## **Soil Textural Classification and Infiltration Rate**

# Proposed Gooding Avenue Hotel Determining Soil Texture NRCS Soil Survey

# Proposed Gooding Avenue Hotel Restricted Infiltration

## Pittstown Soil Sample

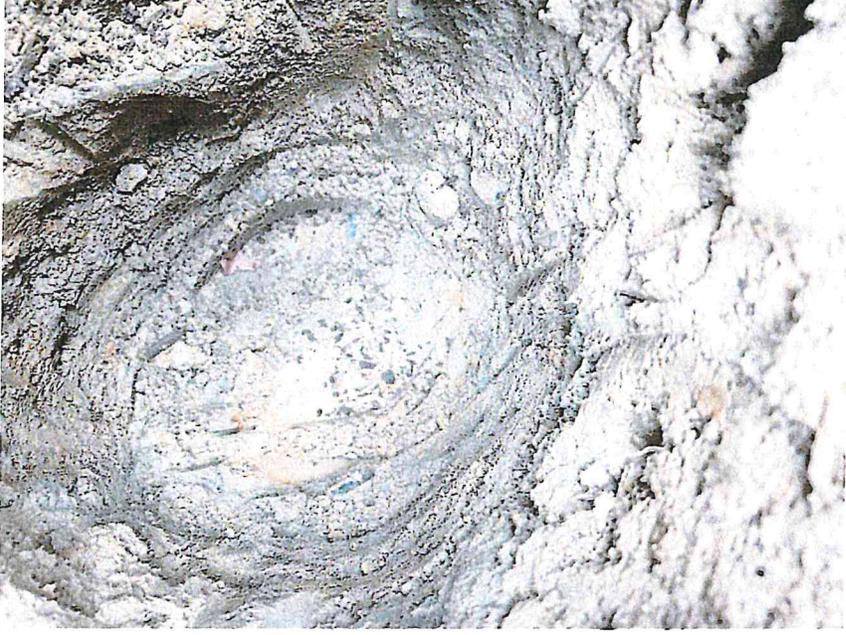
**RAISE  
THE  
RED FLAG**

Soil profile was collected from an undisturbed area of property at 20 Dixon Ave. This area is identified as (Pm) Pittstown soils by NRCS. See the previous slide for the location.

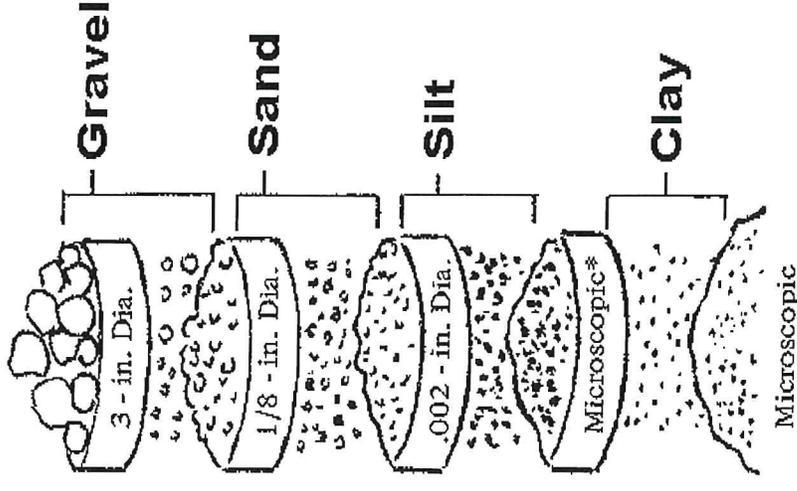
Soil Mottled blue and organ color

Restricted infiltration water is retained in the test hole

# Certified Lab Sieve Analysis Results confirm that the soil is Silt Loam

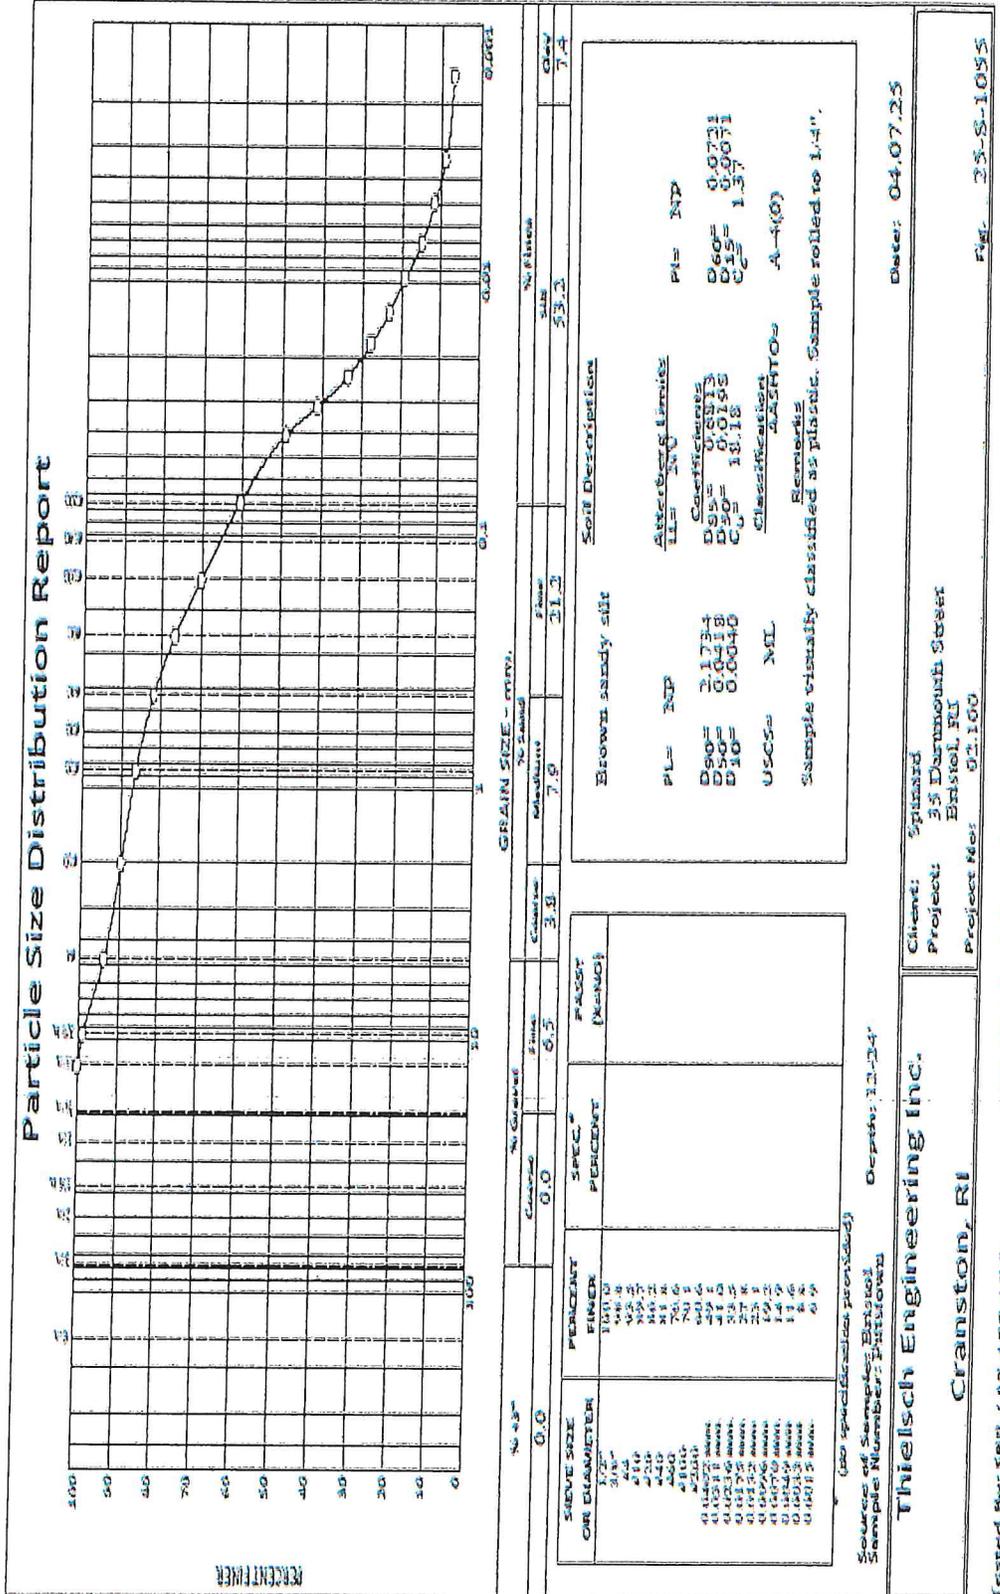
**Lab results classified the soil as ML Silty Loam**

## *Infiltration Feasibility & Rate*

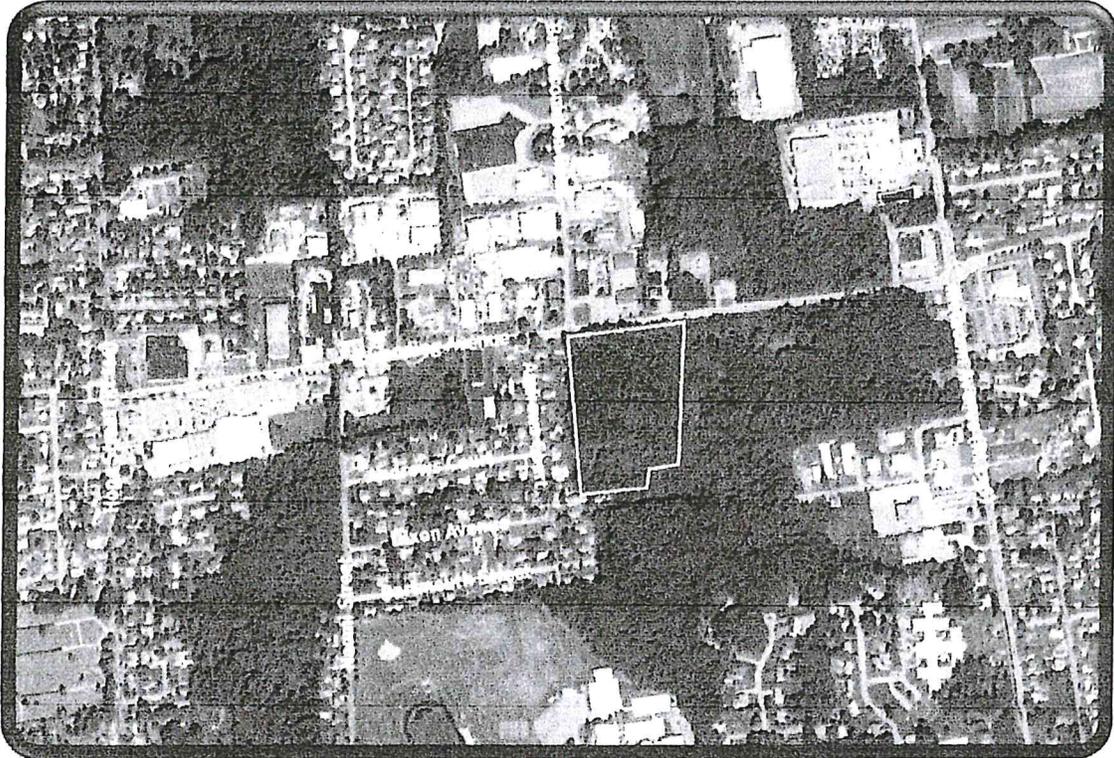
Infiltration Rate Should be 0.27in/hr for Silt Loam, not 0.5 in/hr (much higher) (Sandy Loam) Used by Applicant

RIDEM Table 5-3 Design Infiltration Rates for Different Soil Textures  
Silt Loom 0.27 in/hr infiltration rate

SITC classified the soil as silt loam, and DEM accepted this infiltration rate, but did not allow it to be used for infiltration BMPs

“With respect to the proposed underground retention/ detention system, because the infiltration rate is slower than the minimal standard of 0.5 inches per hour, this proposed BMP cannot be considered an acceptable infiltration practice. With respect to the proposed isolator Row-TM portion of this proposed BMP, it cannot be considered to be an acceptable water quality BMP for full treatment of water quality volume. This is because the Isolator Row-TM practice relies on infiltration as an integral part of its system. Without an acceptable infiltration rate of at least 0.5 inches per hour it is not considered to be a valid water quality BMP” (RI DEM Engineering Review of SITEC Proposed Hotel Facility 6/10/2015)
